**Report: Final Report
Function: Test, Adjust, & Balance
Date: 8/24/2022**

**PROJECT
08-15 CULVERS - WHEATON, IL**

Project: 08-15 CULVERS - WHEATON, IL

E5 HVAC PLAN
 SCALE: 1/4" = 1'-0"

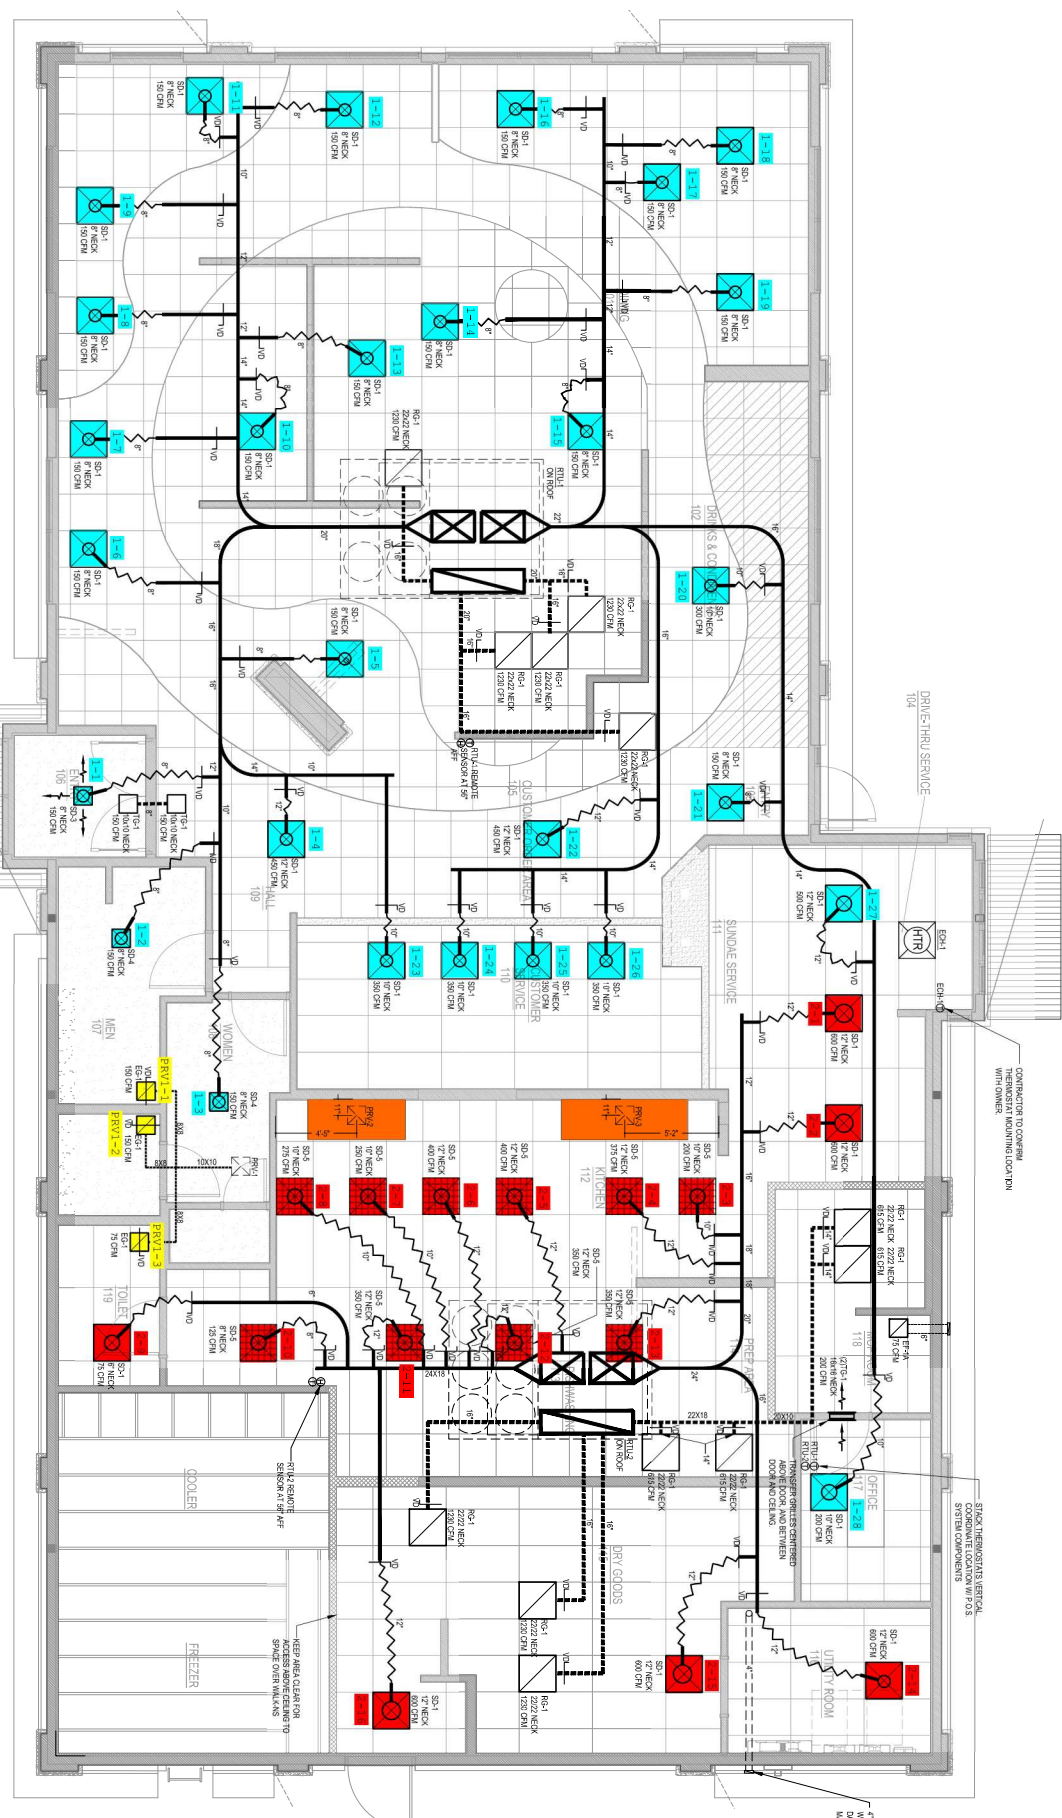
Diffuser 2-14 not yet installed. 10" neck diffuser shipped to site. MC is installing a 12-10" reducer on the diffuser. RTU-1 only has 4 returns installed. Plans call for 5.

Notes: [1] DIFFUSER 2-14 LOW ON AIRFLOW (480/600CFM-80%) DUE TO INCORRECT NECK SIZE. 10" INSTALLED, PLANS CALL FOR 12". REDUCER INSTALLED BEFORE NECK, CANNOT PUSH ANY MORE AIR TO DIFFUSER WITH ALL OTHER DIFFUSERS ACHIEVING DESIGN. [2] INFORMATION TAKEN FROM VFD. RECIEVED PERMISSION FROM CAPTIVE AIRE TO PUSH UNIT TO UNIT STICKER FLA (27.0A) BASED ON UNIT VOLTAGE OF 204V. [3] SERVED BY RIGHT HMI (THERMOSTAT) IN OFFICE.
